City of Sandy

Planning Commission Meeting
Meeting Date: Monday, April 27,
2020
Meeting Time: 7:00 PM

| 6.1. | 19-046 MOD/VAR/DEV Sandy Vault Modification | 12 - 160 |

04

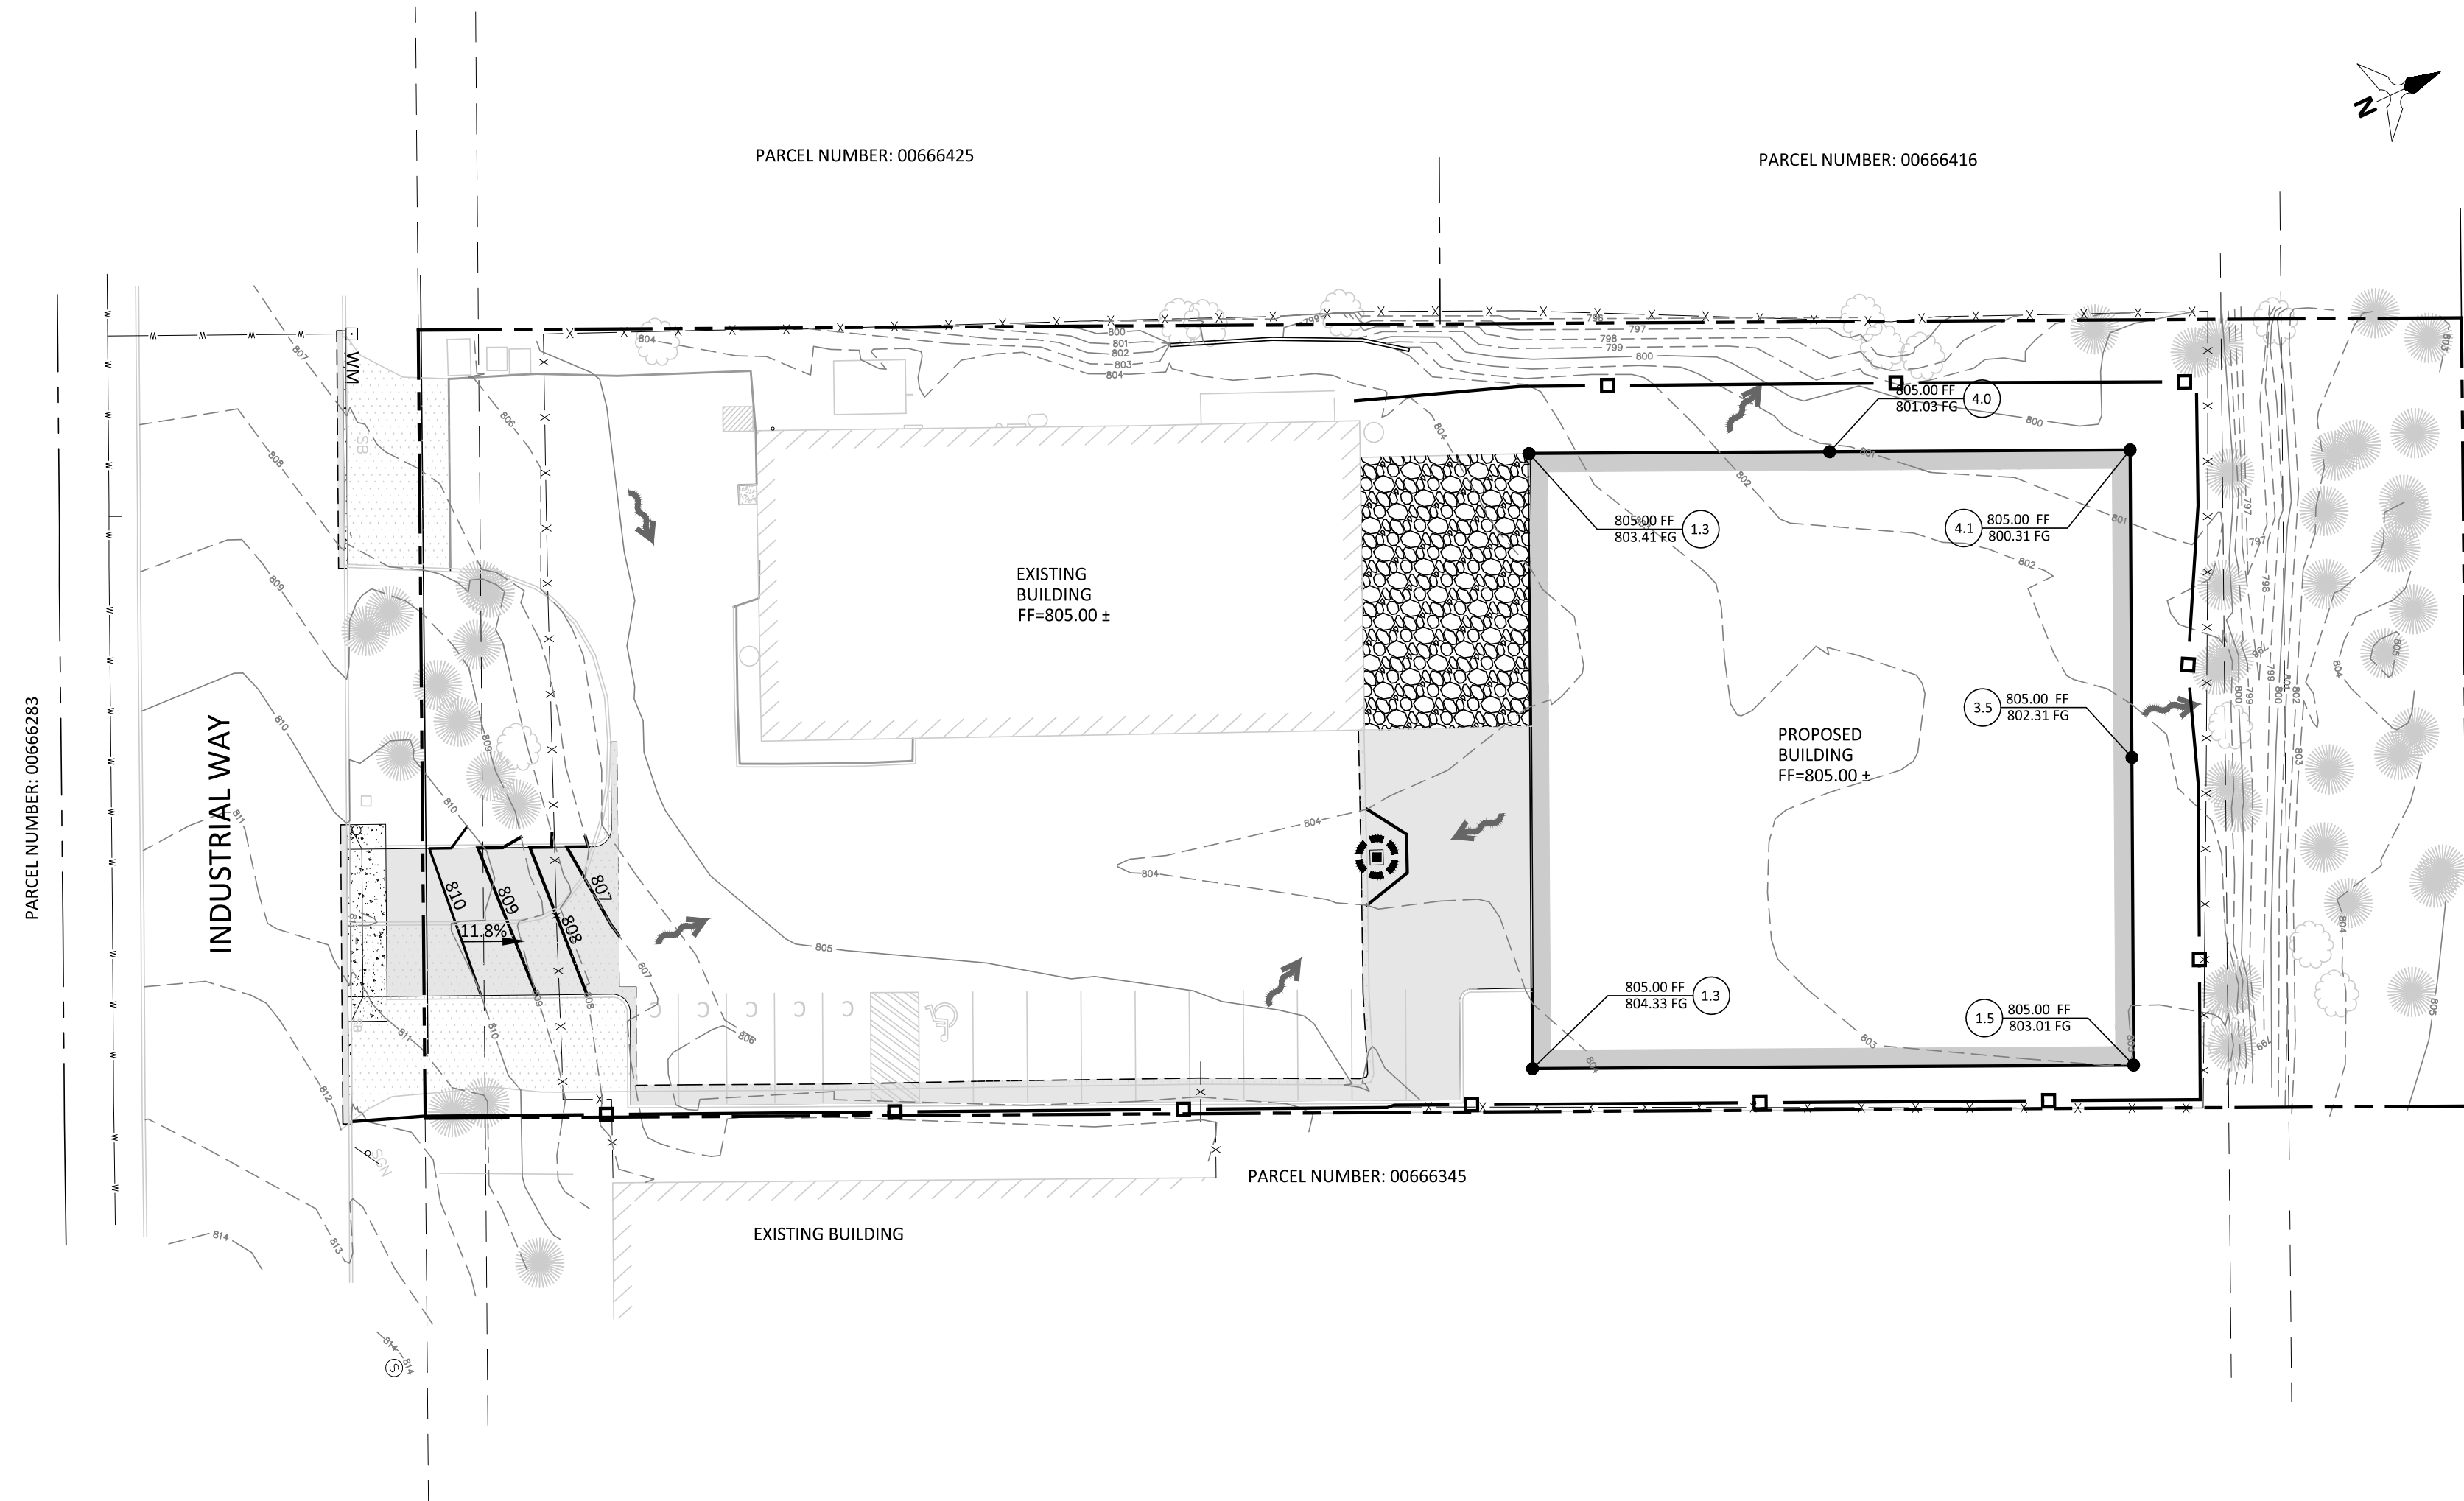
17. Chapter 17.84 contains public improvements required with development. The subject site has driveway access on Industrial Way. The Site Layout and Paving Plan (Exhibit C, Sheet 04) does not detail a sidewalk along the Industrial Way frontage of the site. As noted by the Public Works Director (Exhibit M), sidewalks are required on all public street frontages per section 15.20 and 17.84.30 of the Sandy Municipal Code. The applicant may have intended to request a design deviation to not provide a sidewalk; however, the deviation request cited in the land use application (Exhibit A) is to Section 17.82.30(D). Chapter 17.82 does not apply to this application and design deviations can only be requested to standards in Chapter 17.90; thus, staff reasoned that the requested design deviation was intended as a request to not provide the internal connections required by 17.90.130(A). If the applicant intended to request a waiver of a public sidewalk requirement, that would be a Special Variance; however, staff would not support waiving the requirement to provide public frontage improvements. **The**

42. Section 17.90.130(J) contains standards for external storage. The exterior storage of merchandise and/or materials, except as specifically authorized as a permitted accessory use, is prohibited. The Site Layout and Paving Plan (Exhibit C, Sheet 04) details a gravel storage area located between the existing building and the proposed building. **The applicant shall not park or maneuver any motorized vehicles on the gravel area as that would be a violation of Section 17.98.130.** The Existing Conditions and Demolition Plan (Exhibit C, Sheet 03) details removal of two (2) existing shipping containers. **The applicant shall remove all shipping containers from the site prior to receiving a certificate of occupancy.**
